RE: JMC Project 20044
 4 Tripp Lane Zoning Compliance
 4 Tripp Lane
 Town of North Castle, New York

Response to Kellard Sessions and Town of North Castle Planning Department Comments

This letter has been prepared to address comments and correspondence received from Kellard Sessions, dated September 22, 2023, the Town’s Planning Department staff report dated September 19, 2023, and HydroEnvironmental Solutions, Inc., dated September 22, 2023.

AVERAGE GRADE DIAGRAM

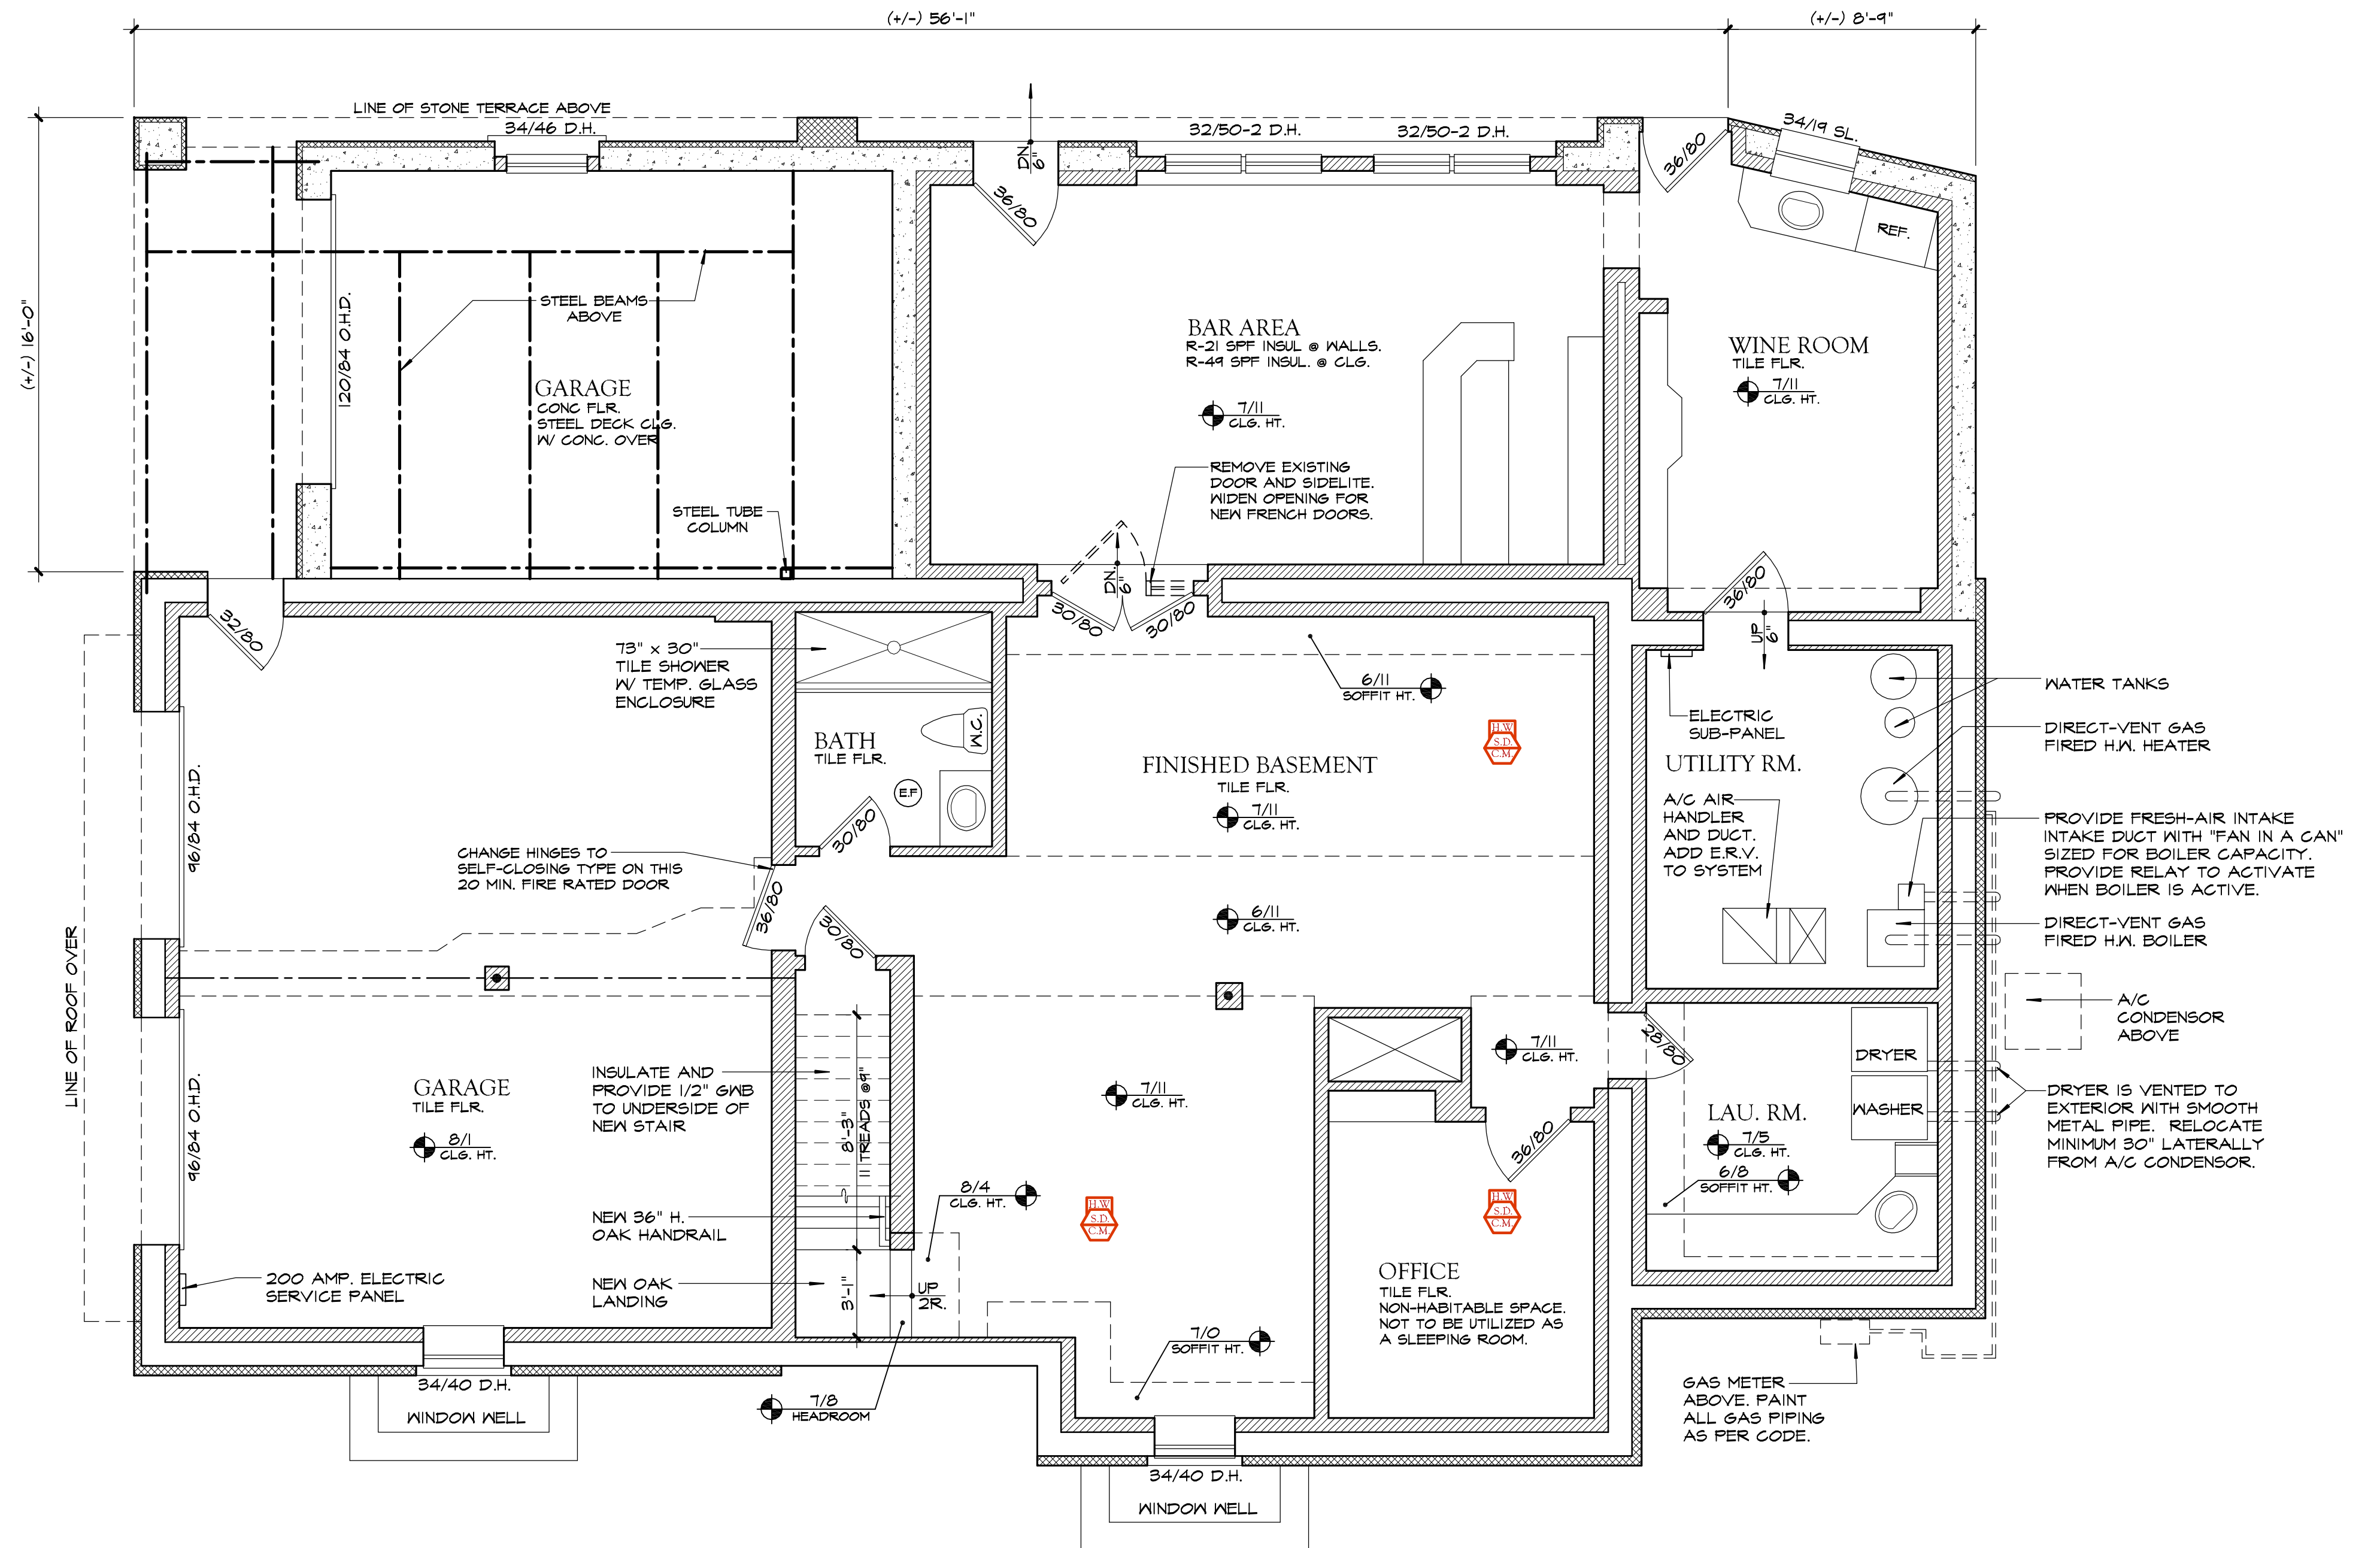
The submitted gross floor area calculations worksheet does not include the floor area of the garage or basement. Garage space is required to be counted as part of gross floor area. The Applicant shall also provide an exhibit demonstrating that the basement level would be excluded pursuant to the definition of gross floor area.

It is the Architect's opinion that the basement and garage should not be included in the gross floor area calculations as shown on the average grade diagram on drawing A1 that has been included with this submission.
